Attached find addendum to recent Tier 2 RBCA for Former Oakland Tribune Site in Oakland, California. I will mail a hard copy to you tomorrow.

Subject: Addendum to Tier 2 RBCA Assessment
Former Oakland Tribune Site
2302 Valdez Street, Oakland, California
Alameda County LOP Site ID 3663
GA 125-01-02

**GSI RBCA MODEL OUTPUT TABLES FOR PROJECT SITE
BUILDING USING REVISED INPUT PARAMETERS**

**REVISED SITE PLAN AND GSI RBCA MODEL OUTPUT FOR
OFFSITE RESIDENTIAL APARTMENT BUILDING**

DESIGNED BY:	CHECKED BY:	GROUNDWATER HYDROCARBON RESULTS, VARIOUS DATES FORMER OAKLAND TRIBUNE SHOP OAKLAND, CALIFORNIA	DATE: 02/27/98	FIGURE: 5
DRAWN BY: JG	SCALE:			
PROJECT NO: 125-01-02			GRIBI Associates

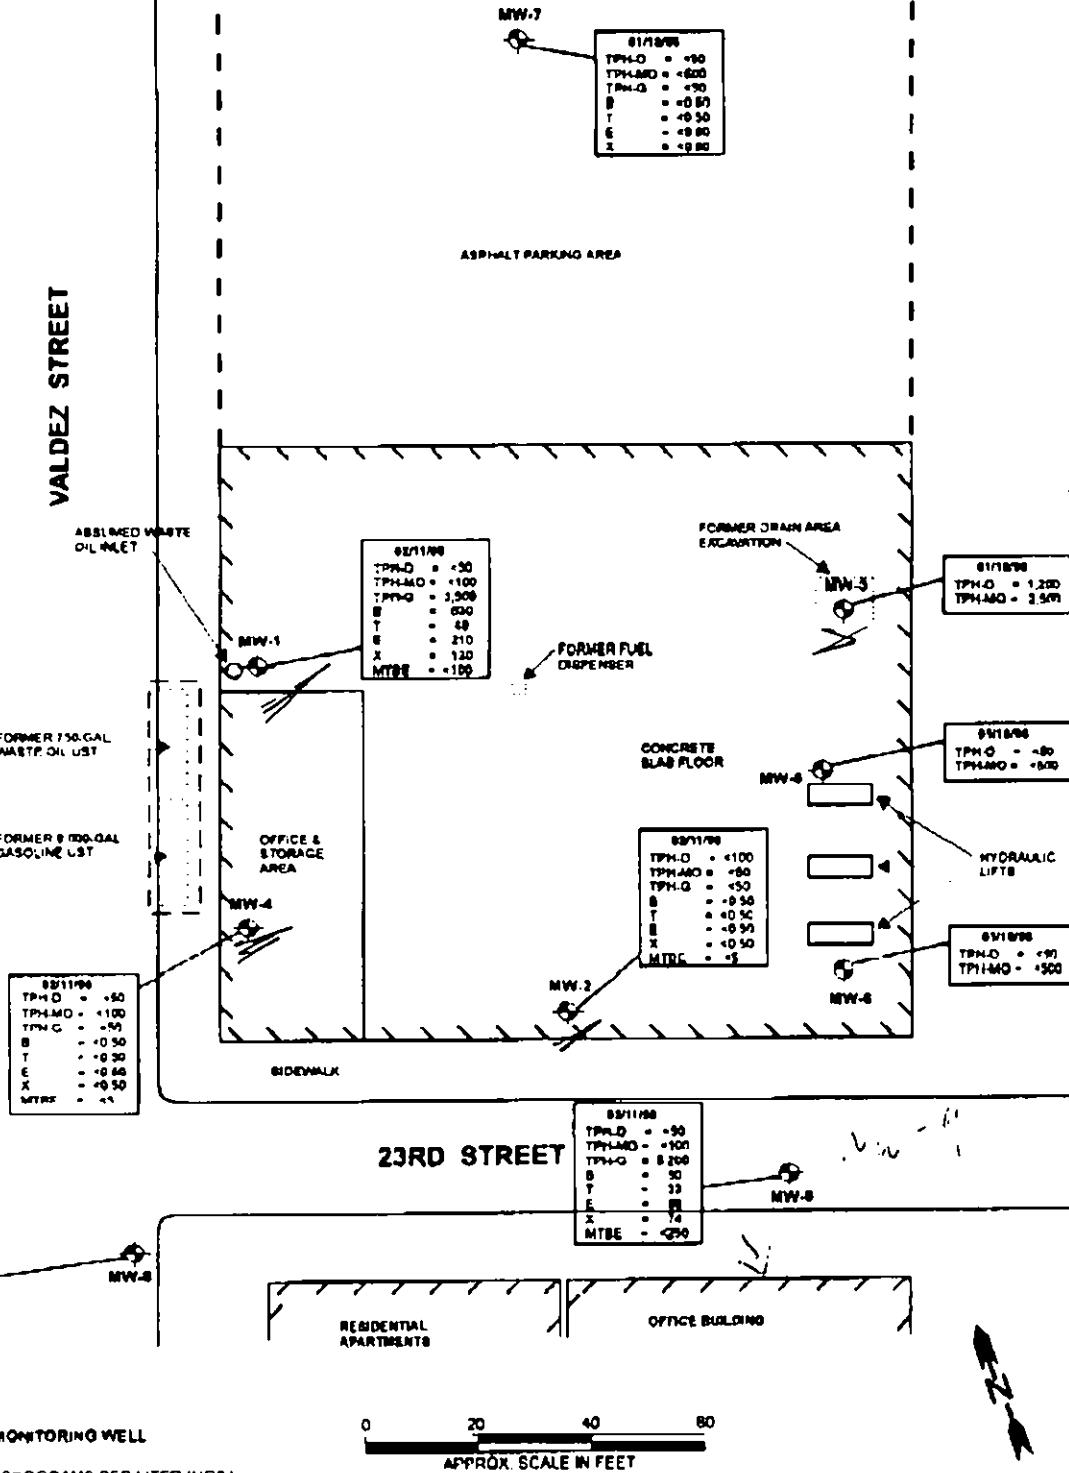
The only identified potentially downgradient residential receptor is a residential apartment building located about 70 feet south from the project site, on the southeast corner of 23rd Street and Valdez Street. A revised site plan showing the location of this residential apartment building is included in Attachment B.
